NIAGARA MOHAWK POWER CORPORATION

LICENSE NO. DPR-63

Proposed Changed to Technical Specifications (Appendix A)

Supporting Information and No Significant Hazards Conditions Analysis

Figure 3.1.7f Maximum Allowable Average Planar LHGR Applicable to P8DRB299 and Future Reload Fuel as described in Reference 15.

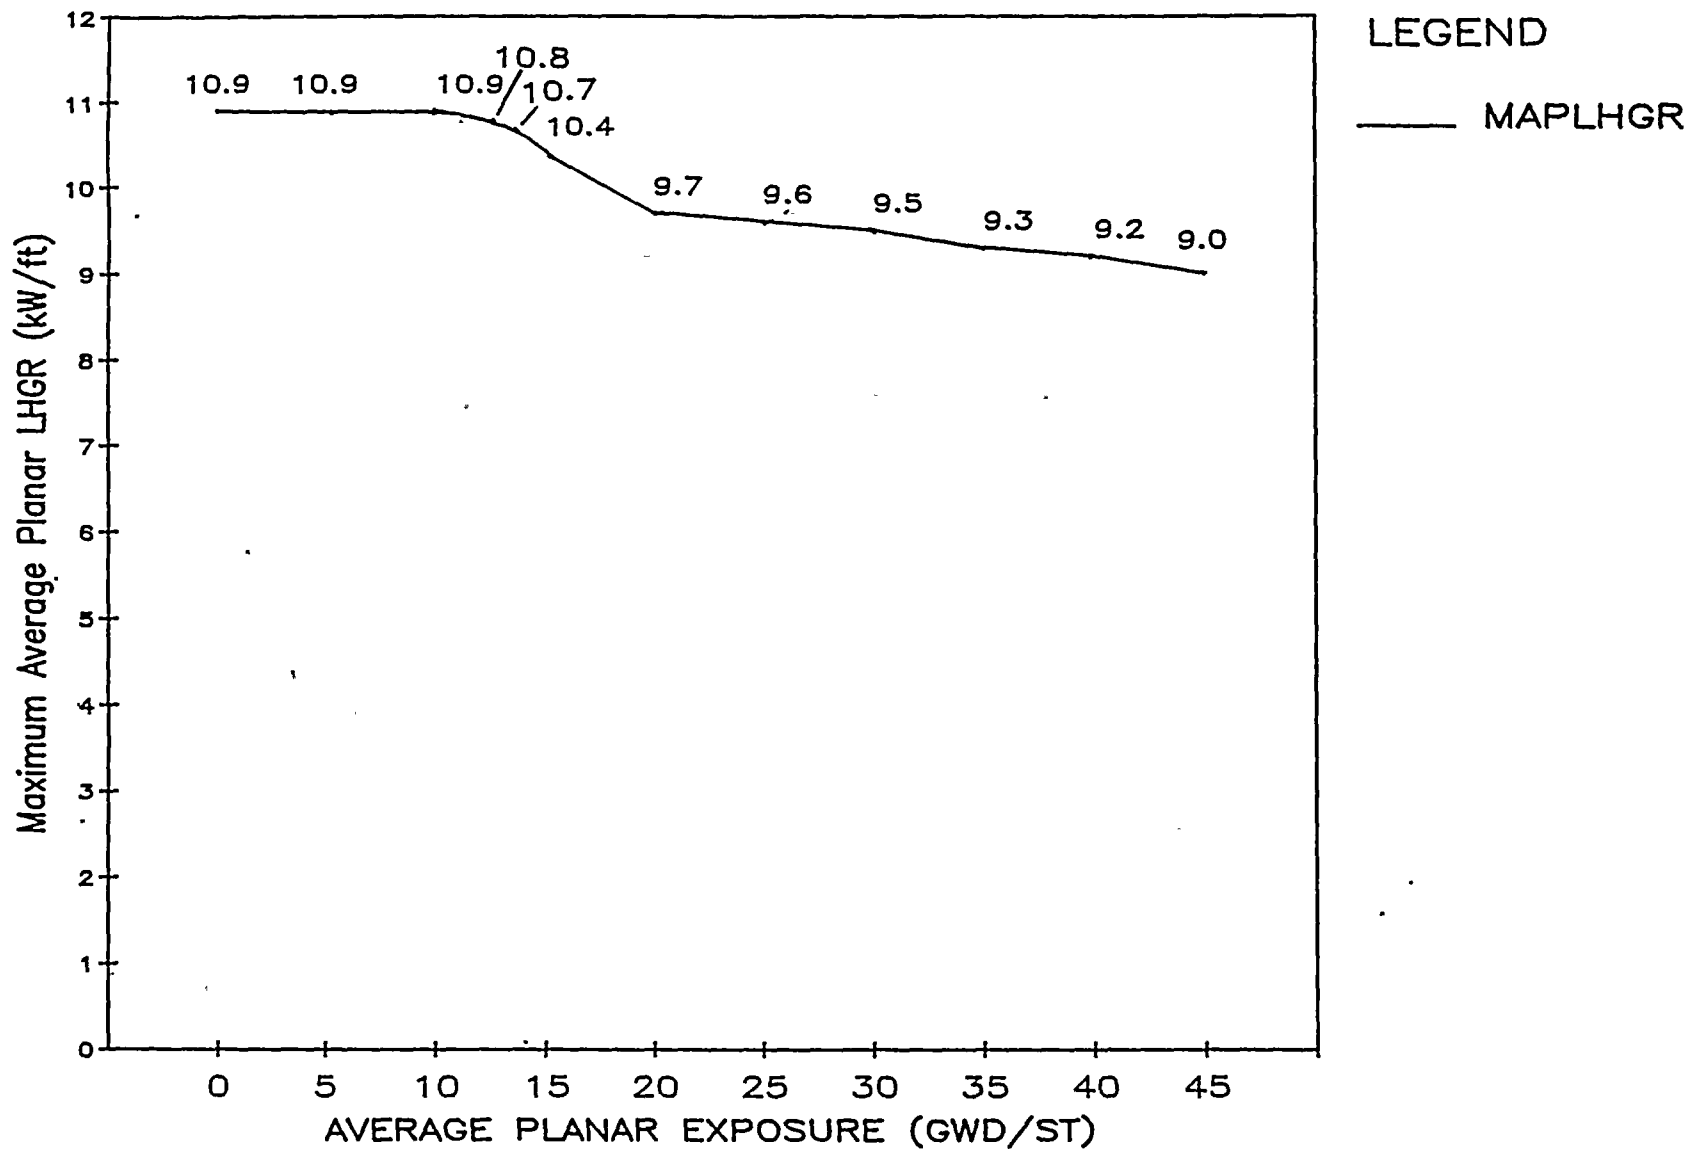
When operating with four recirculation loops in operation and the remaining loop unisolated, the reactor may operate at 100 percent of full licensed power level in accordance with Figure 3.1.7aa and an APLHGR not to exceed 98 percent of the limiting values shown in Figures 3.1.7a, 3.1.7b, 3.1.7c, 3.1.7d, and 3.1.7e and an APLHGR not to exceed 99% of the limiting values shown in Figure 3.1.7f.

When operating with three recirculation loops in operation and the two remaining loops isolated or unisolated, the reactor may operate at 90% of full licensed power in accordance with Figure 3.1.7aa and an APLHGR not to exceed 96 percent of the limiting values shown in Figures 3.1.7a, 3.1.7b, 3.1.7c, 3.1.7d, and 3.1.7e and an APLHGR not to exceed 99% of the limiting values shown in Figure 3.1.7f.

The proposed amendment of Figure 3.1.7(f) and Specification 3.1.7 to the Technical Specifications reflects the use of the SAFER/CORECOOL computer code and methodology to establish the Maximum Average Planar Linear Heat Generation Rate (MAPLHGR) limits for the General Electric fuel bundle, type P8DRB299 (Reference 1). Changes to Specification 3.1.7 affect the Limiting Conditions of Operation and Bases for 3.1.7 and 4.1.7 Fuel Rods. Justification for these changes is provided in Report NEDC-31446P (Reference 3, copy attached).

For fuel bundles analyzed with the methodology used in Reference 13, MAPLHGR shall be reduced 2% and 4% for 4 and 3 loop operation respectively. For fuel bundles analyzed with the methodology used in Reference 15, MAPLHGR shall be reduced by 1% for both 4 and 3 loop operation.
